寄件者: Thomas Wan <[redacted]>
寄件日期: 2026年10月13日星期二 14:30
收件者: William Shu Tai WONG/PLAND
副本: Kit Lo; Johnny Chung Yin LAM/PLAND; Adrian Tsz Hin TAM/PLAND
主旨: RE: Planning Application No. A/NE-MUP/236
附件: RE: Planning Application No. A/NE-MUP/236; Lots 188(Part) and 189RP, Demarcation District No.38 (4).pdf

Application Location:
Lots 188(Part) and 189RP,
Demarcation District No. 38

Drawing Title:
Swept Path Plan

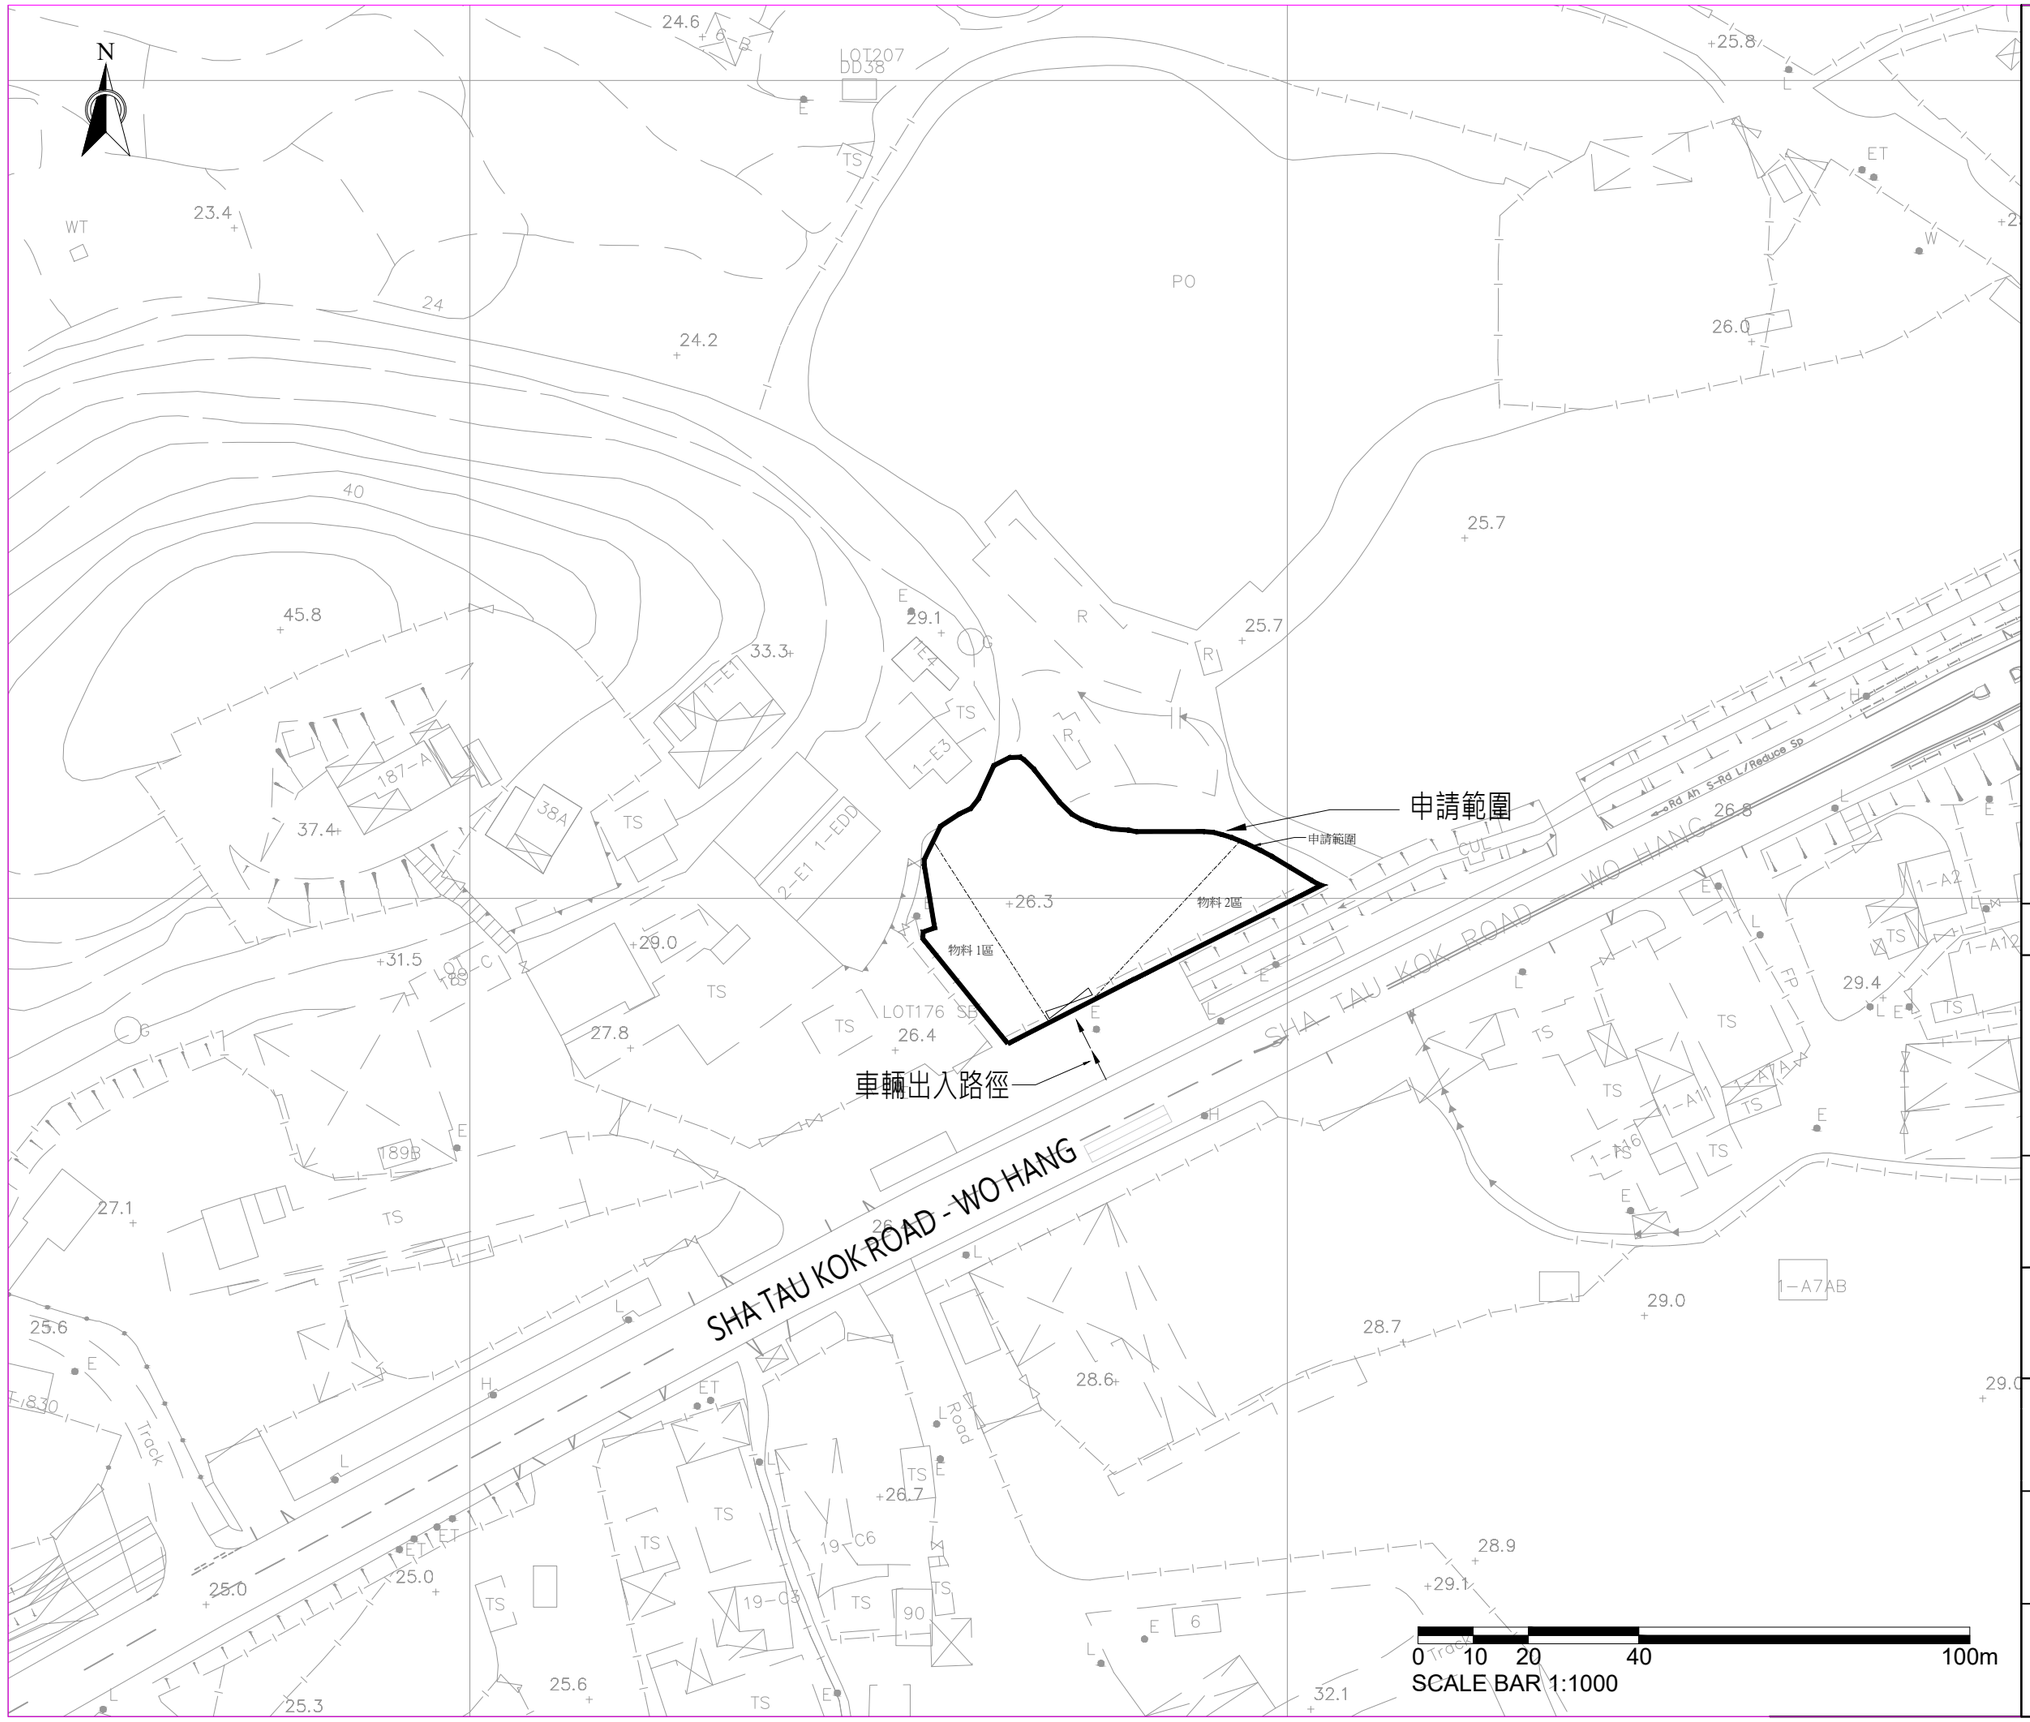
I have no further comment on the swept path analysis. Please liaise PlanD for the further information submission.

Drawing Title:
11m Swept Path 1

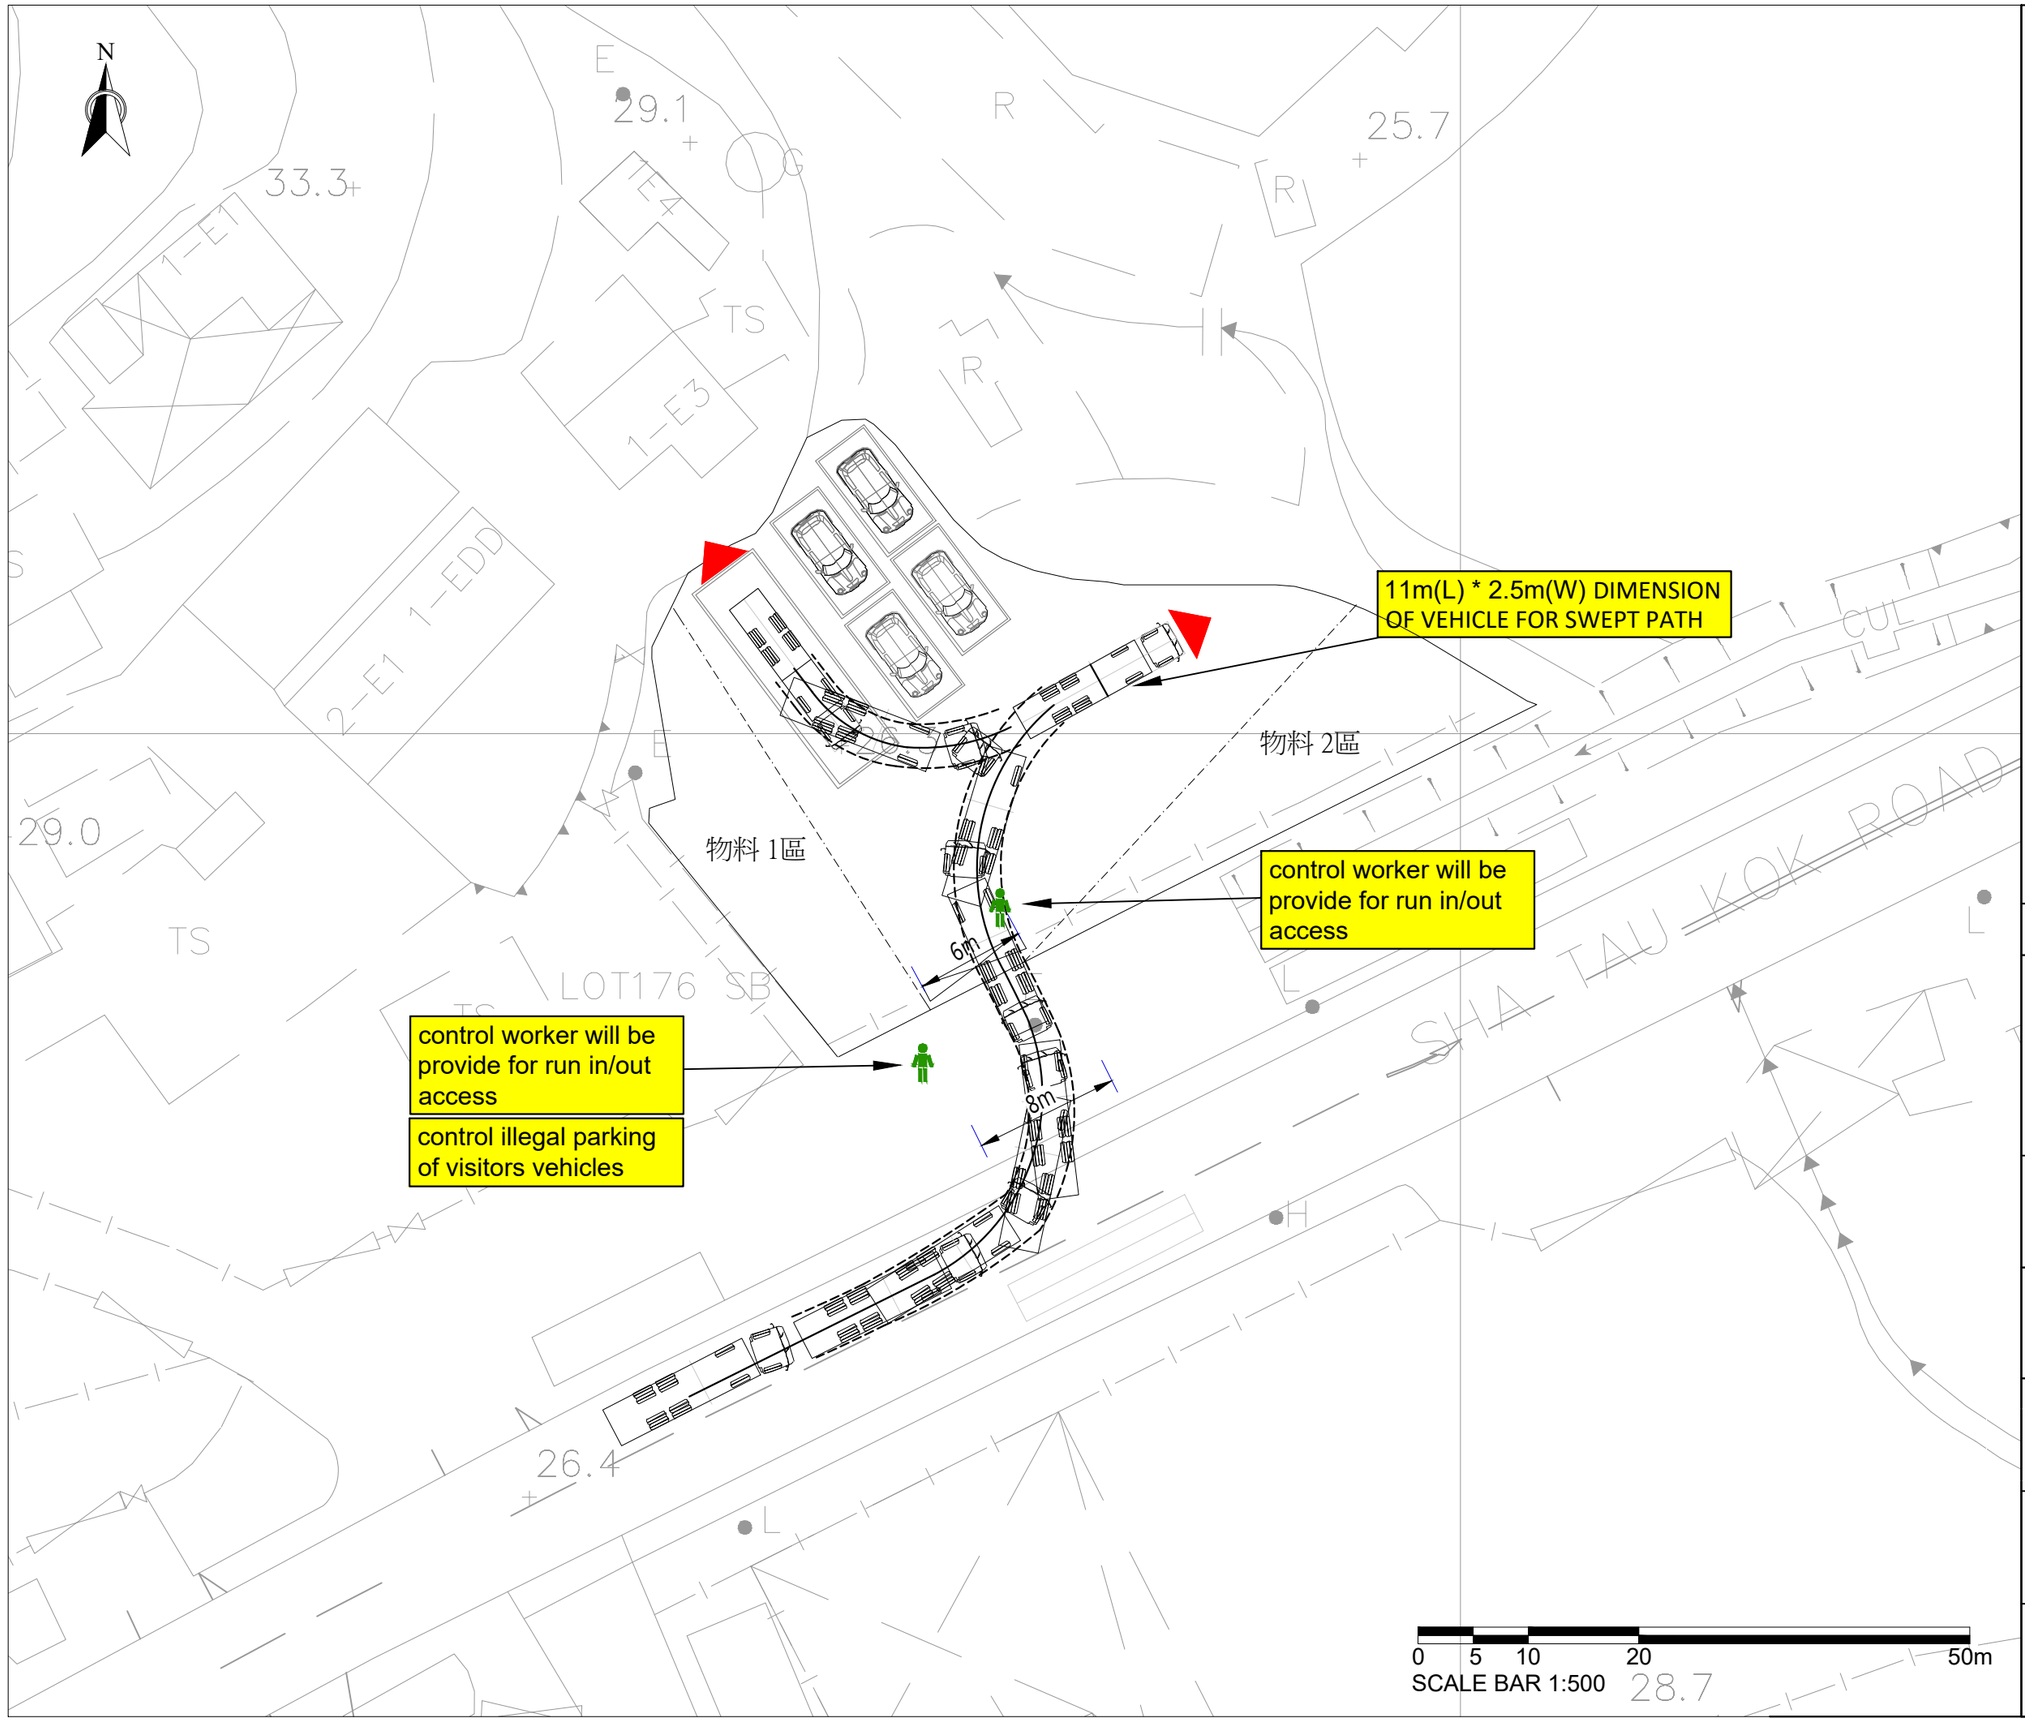
1. The submitted swept path analyses do not accurately reflect the actual situation of the maneuvering of the 11m x 2.5m heavy goods vehicles entering and exiting the subject site. The applicant should rectify it;

2. The applicant should ensure the HGV would not encroach onto the opposite lane when entering/leaving Sha Tau Kok Road to/from the application site; and

Received reply from your side as below. DWG has been amended.
Would you please let me know if any need to revise.

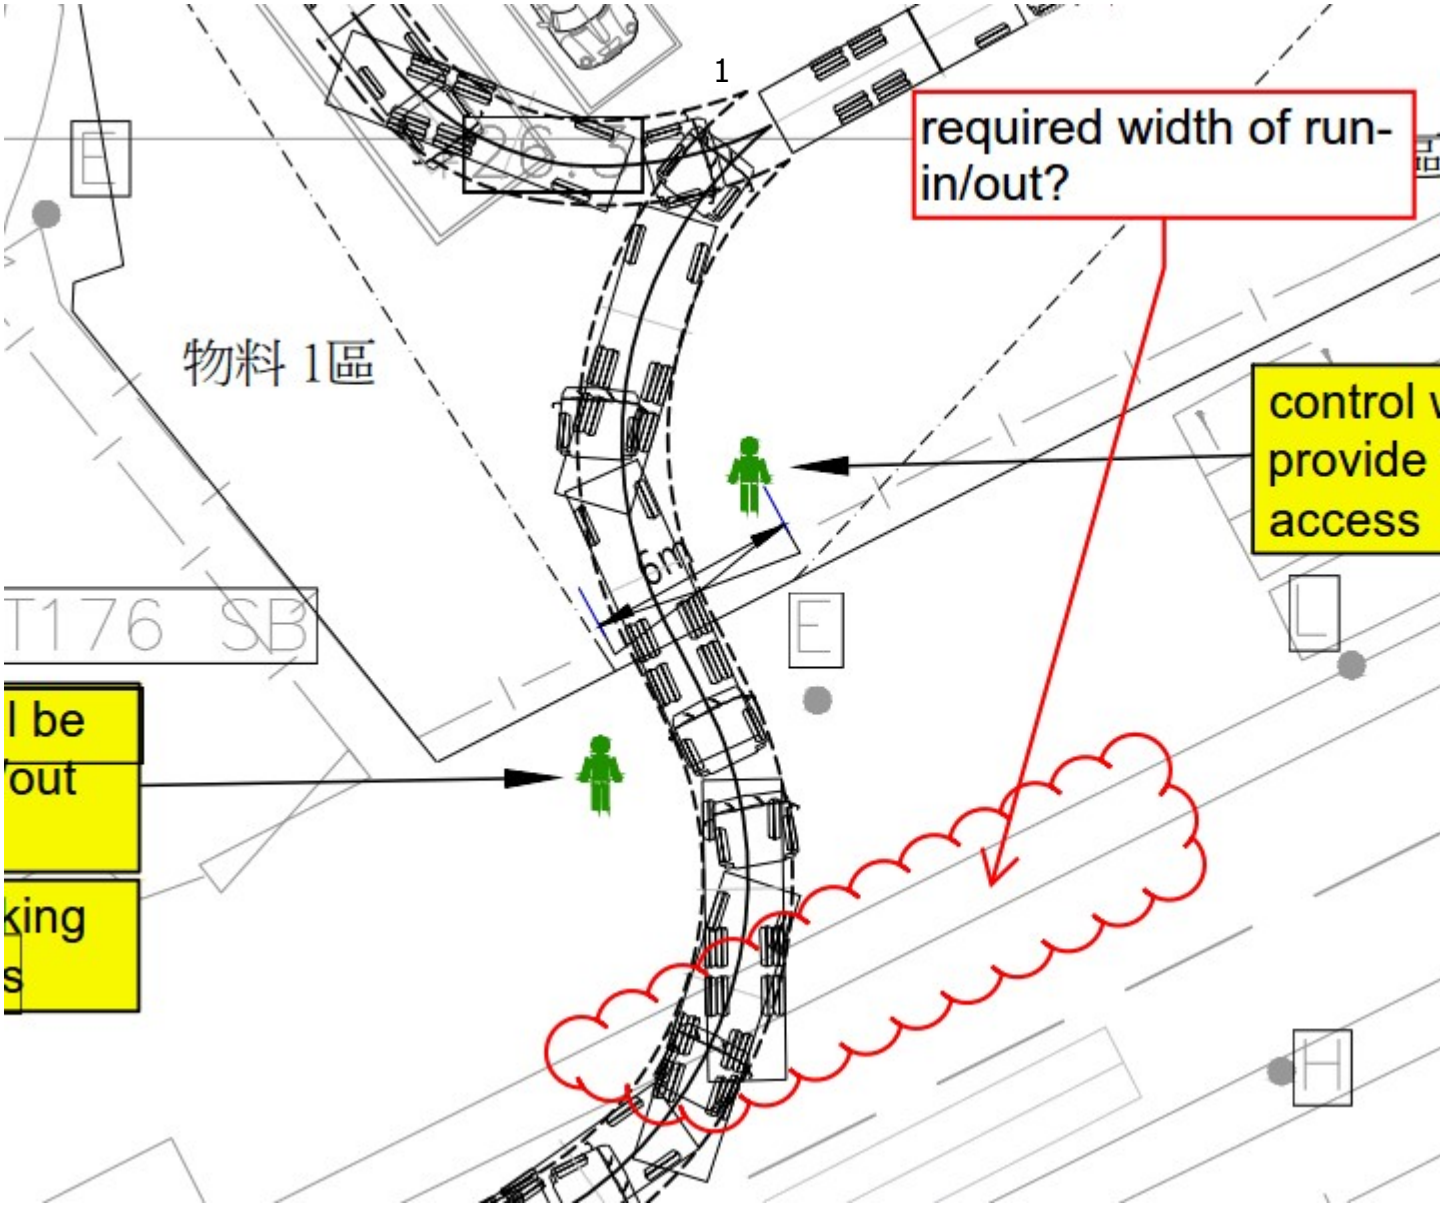
Please also advise the width of the run-in/out.

3. The applicant should specify the width of the run-in/out.

DWG updated with run in / out around 8M.
